Model : SM-G928W8

Revision : REV0.8

# Setup(2015-05-20)\_HHP

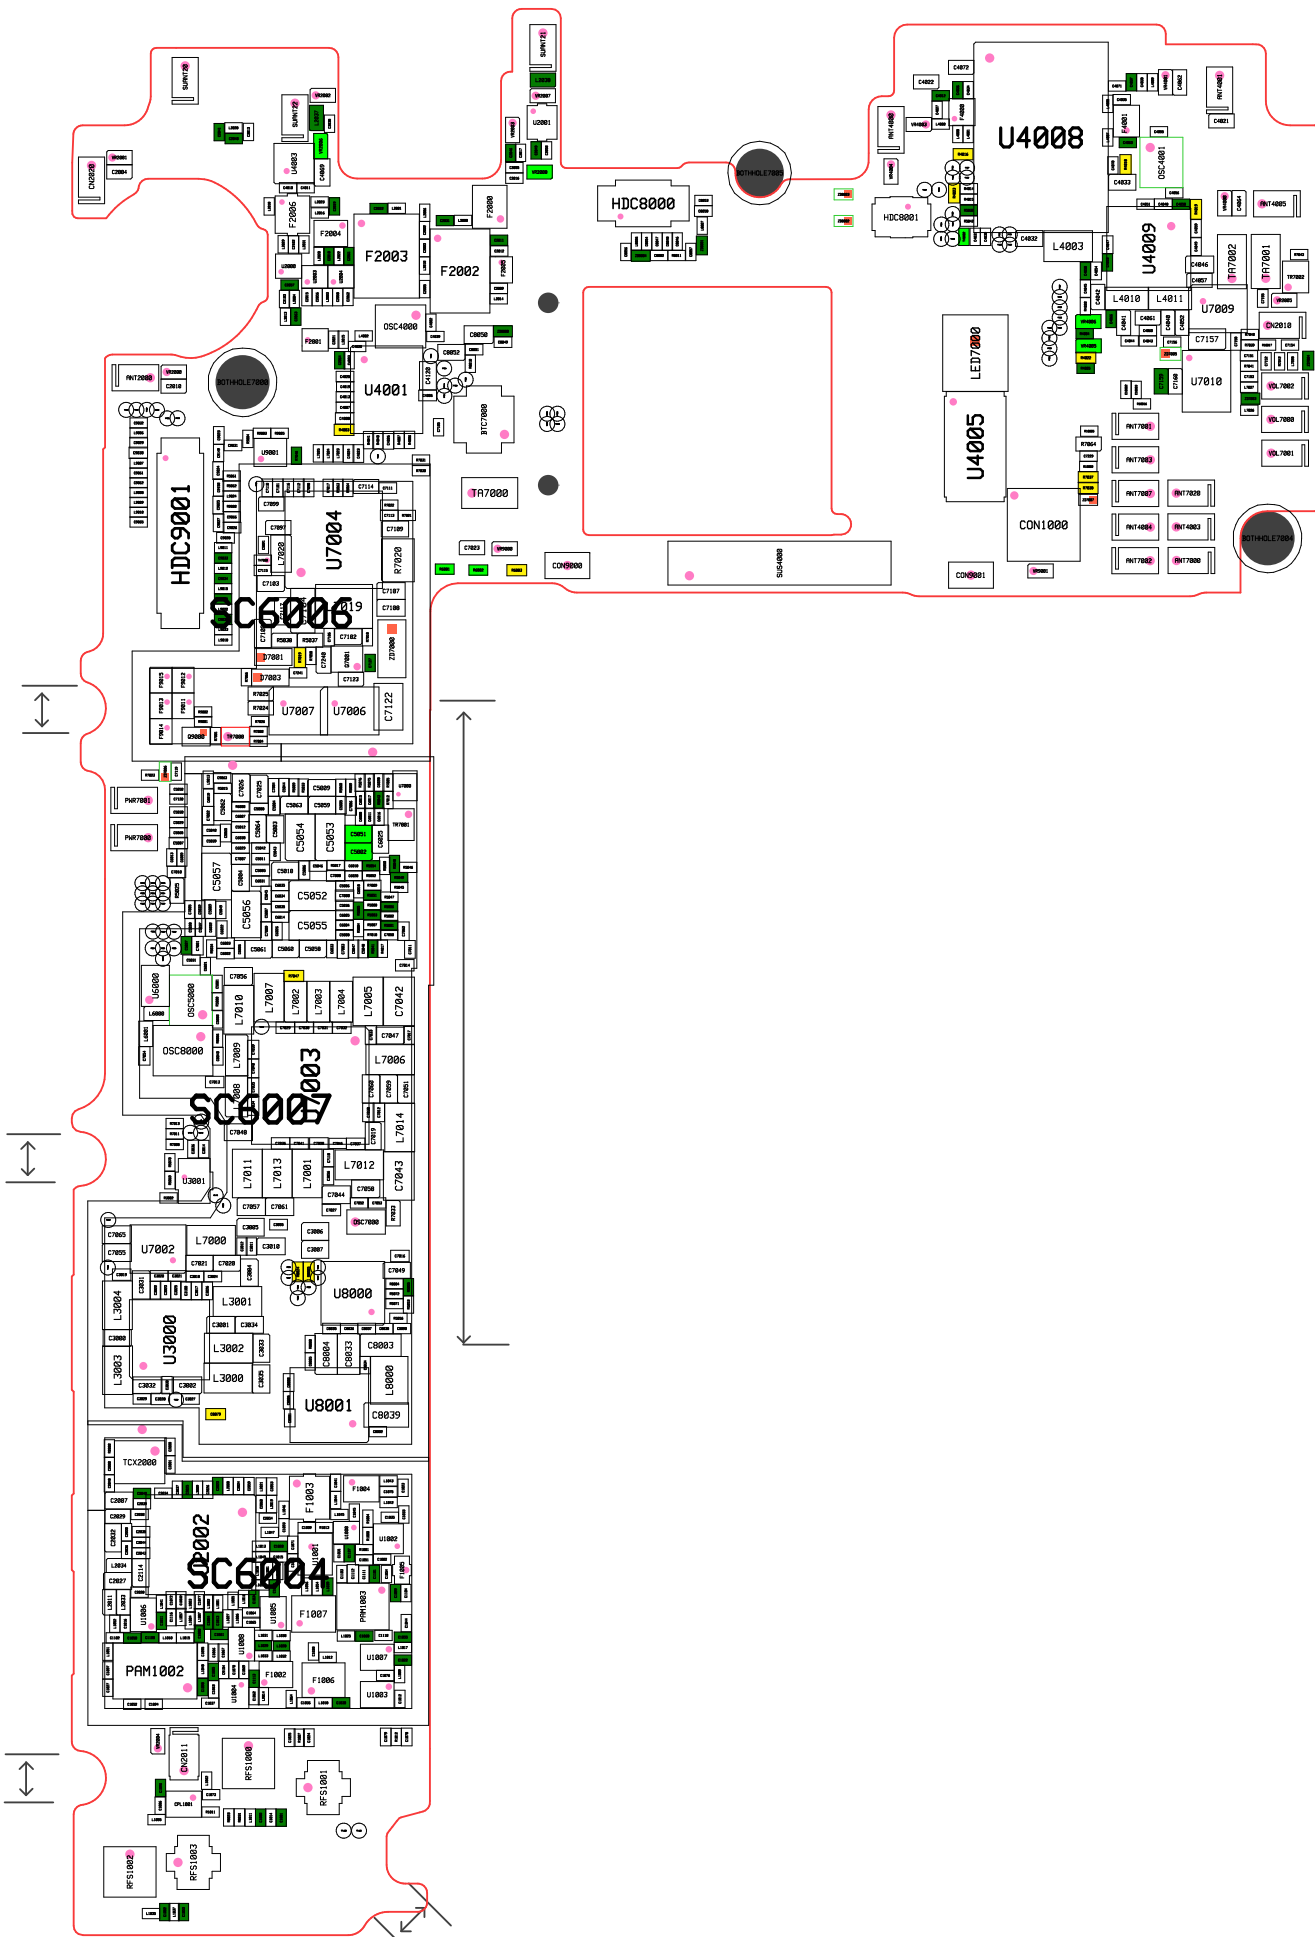
AON1605(TR7000) : IT'S Wrong Polarity possibility. Check the Pin1  
2007-010848(R10004) : Check! Bottom Surface of Component

Setup(2015-05-20)\_HHP

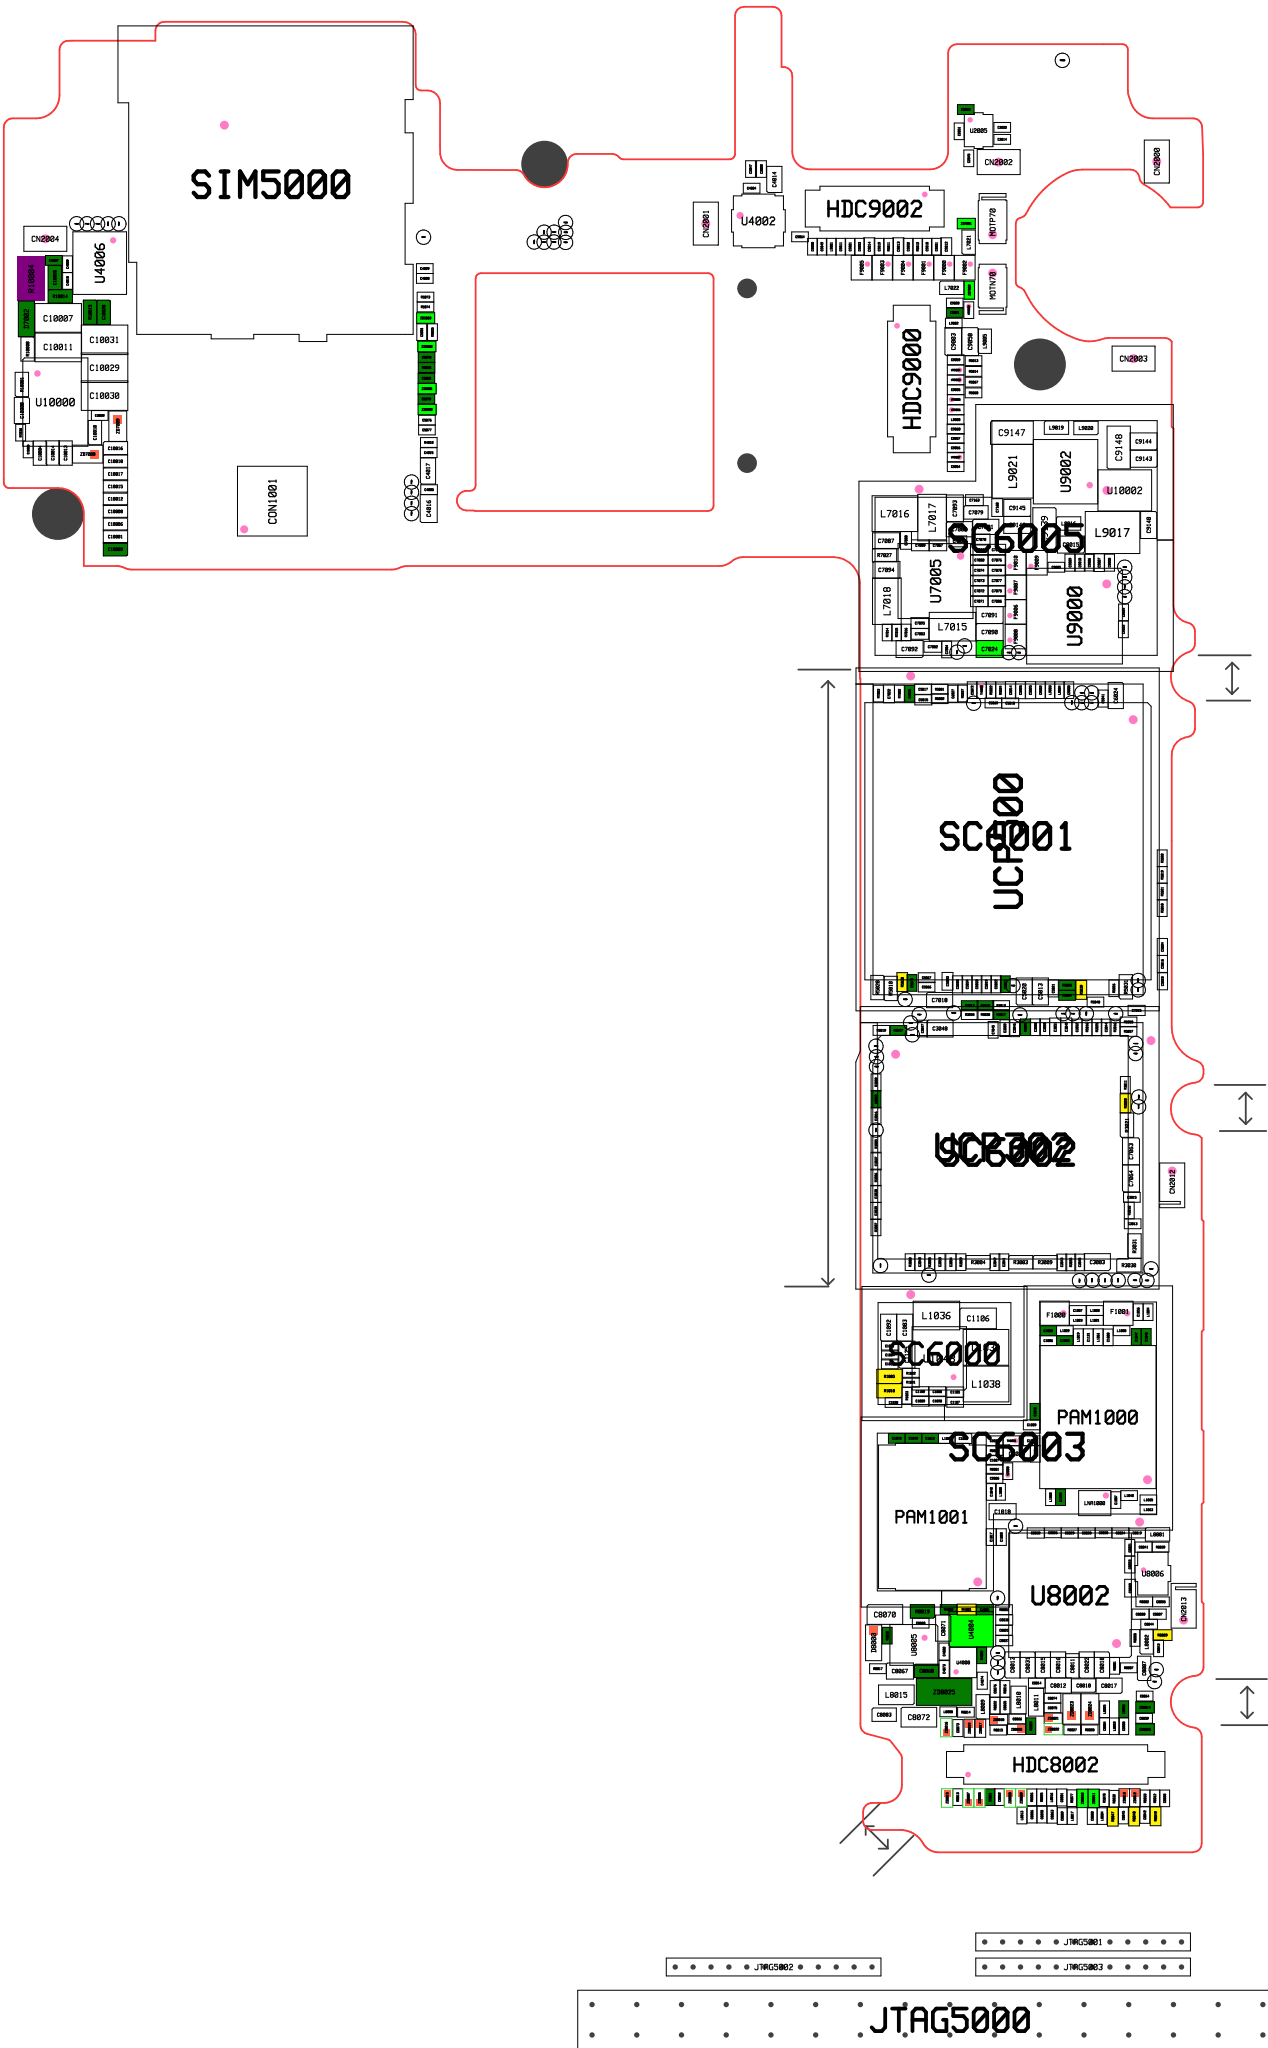
AON1605(TR7000) : IT'S Wrong Polarity possibility. Check the Pin1  
2007-010848(R10004) : Check! Bottom Surface of Component
